**Planned Unit Development -
Lots 1 & 16 Harrison Hills—Streck, Inc.**

RECOMMENDATION REPORT

CASE NUMBER: PPUD-19-0002

RE: Planned Unit Development – Initial Review
Streck, Inc. – Harrison Hills

LEGEND

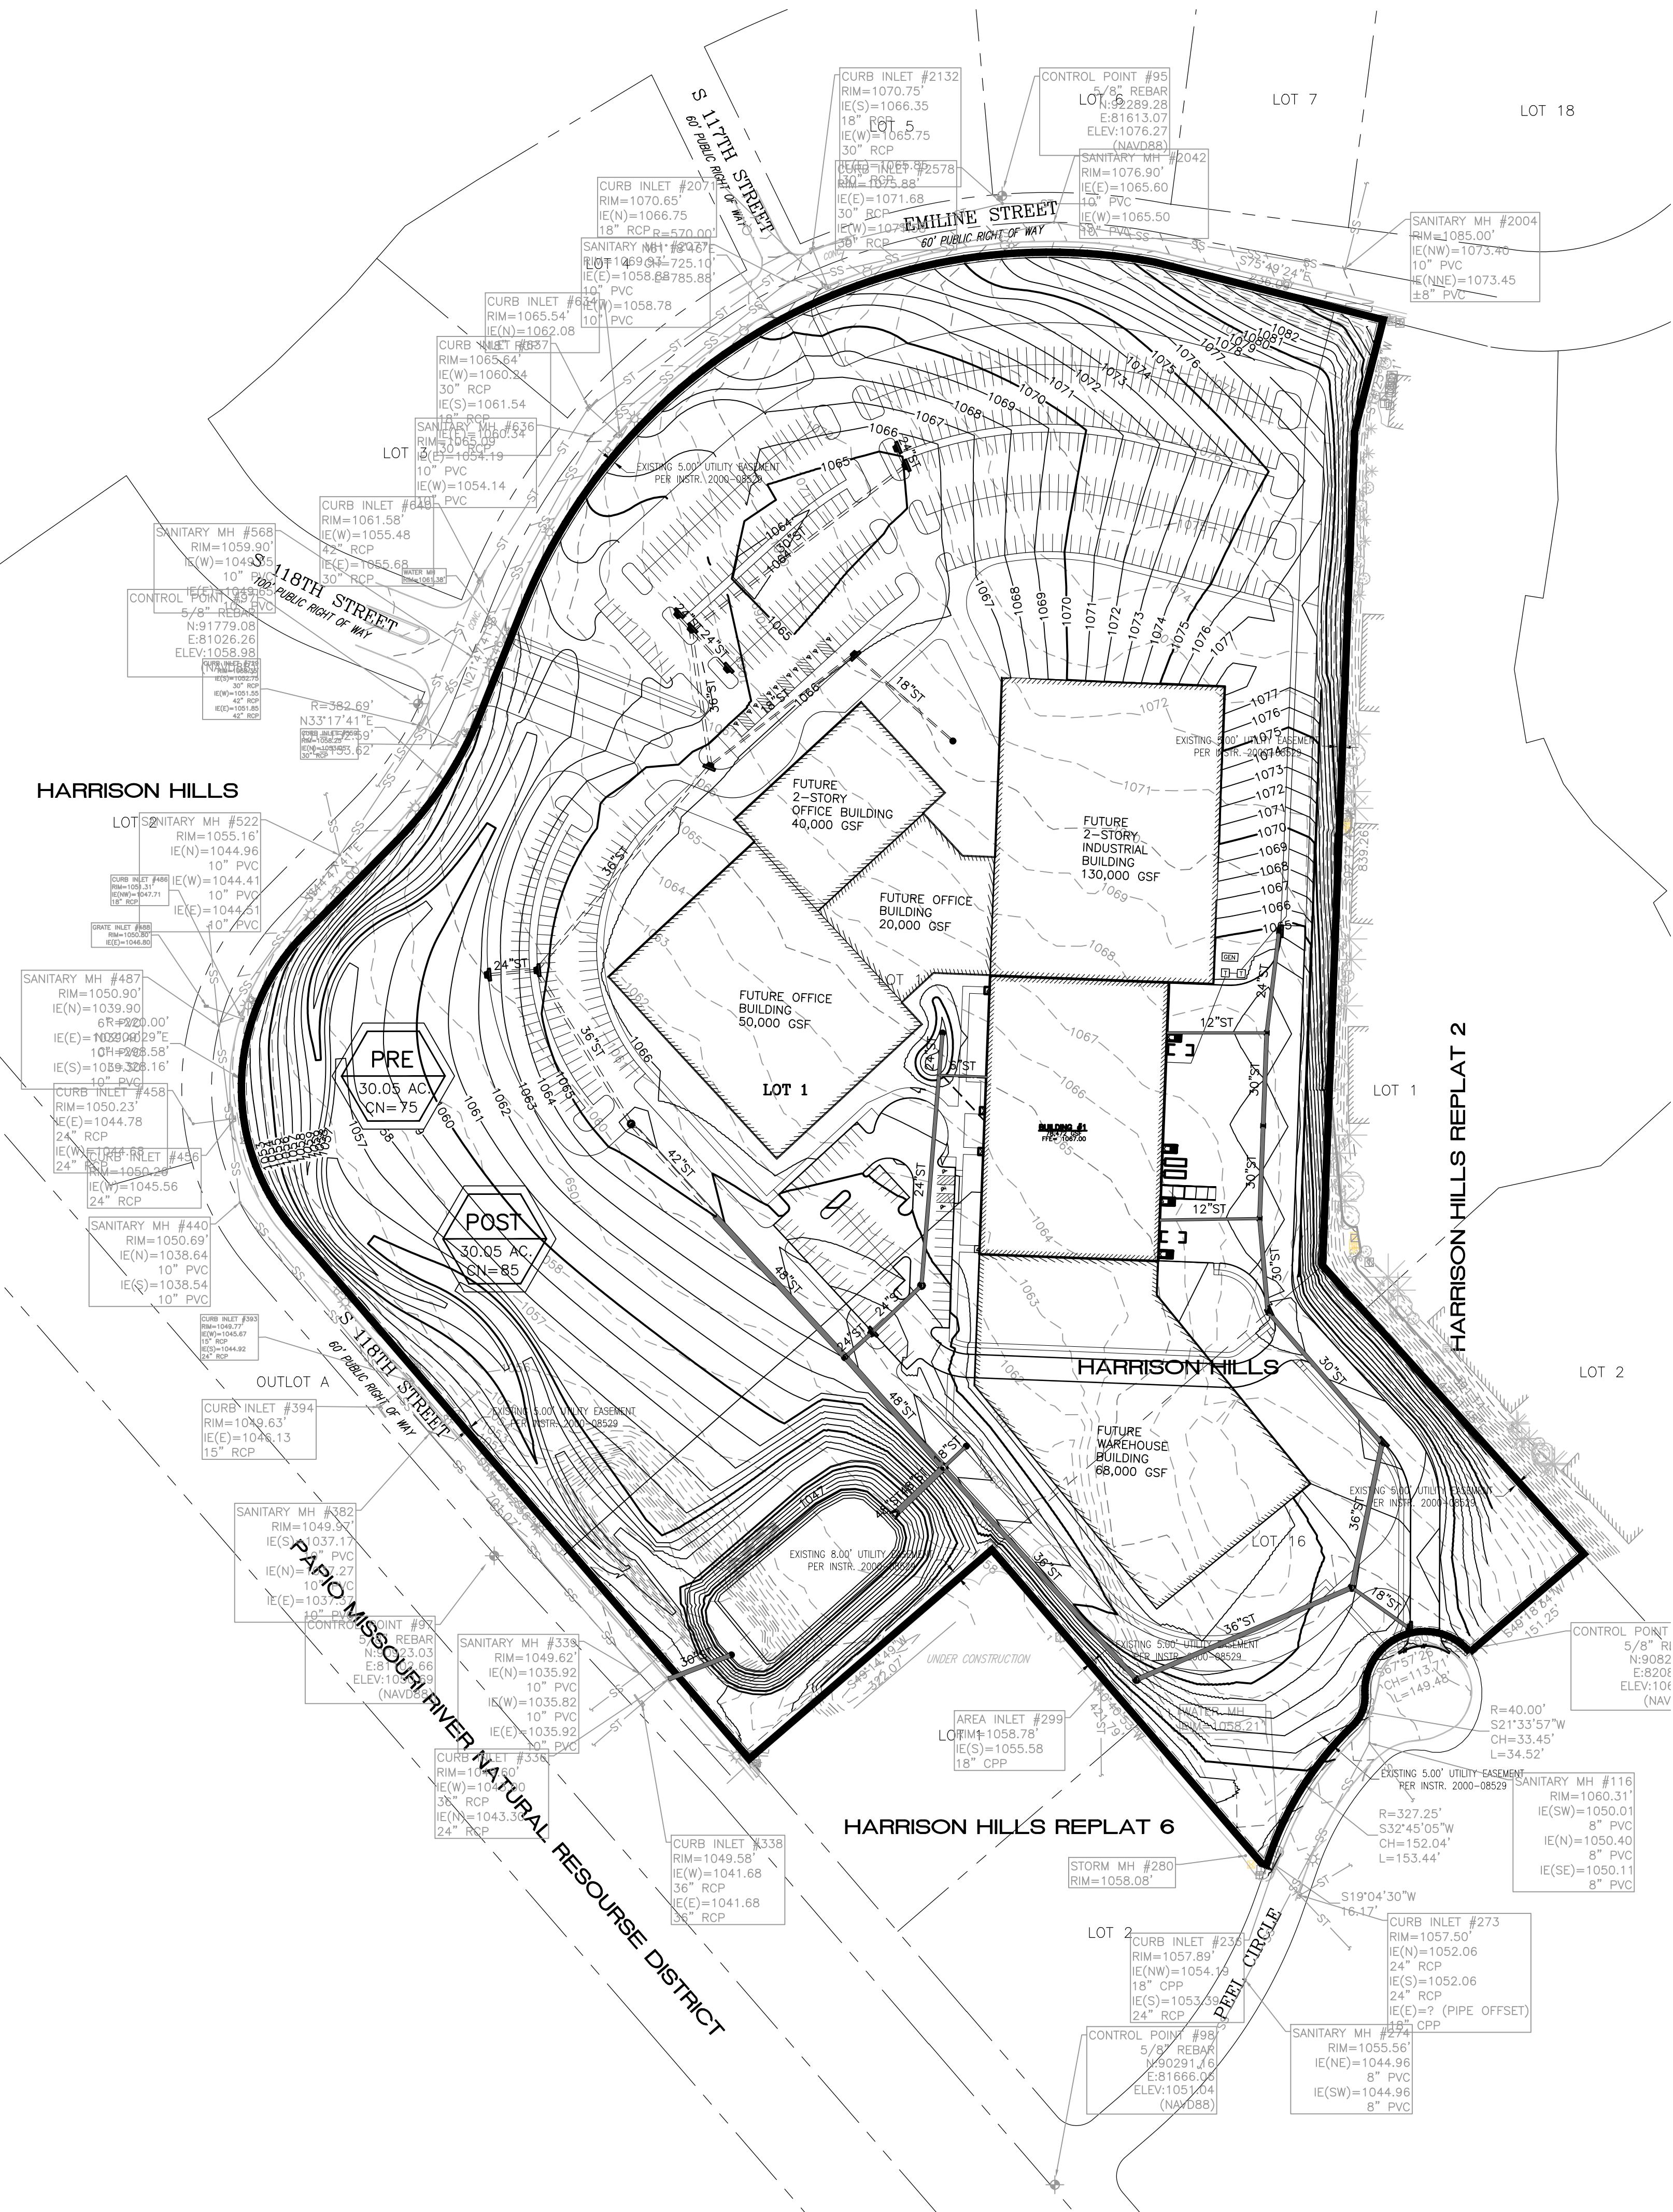
6. Comment Response #11 – Sanitary sewer connection fees and stormwater management fees were noted per the PUD Development Fee Table per the PUD Phasing Plan Exhibit, however the fee rates were not consistent with the current Master Fee Ordinance. Current Watershed Fees are \$4,963/acre (as of 7/1/19) and Sewer Connection Fees are \$7,407/platted acre (as of 1/1/2019).

Response: The PUD Development Fee Table has been updated per the 2019 fees listed above.
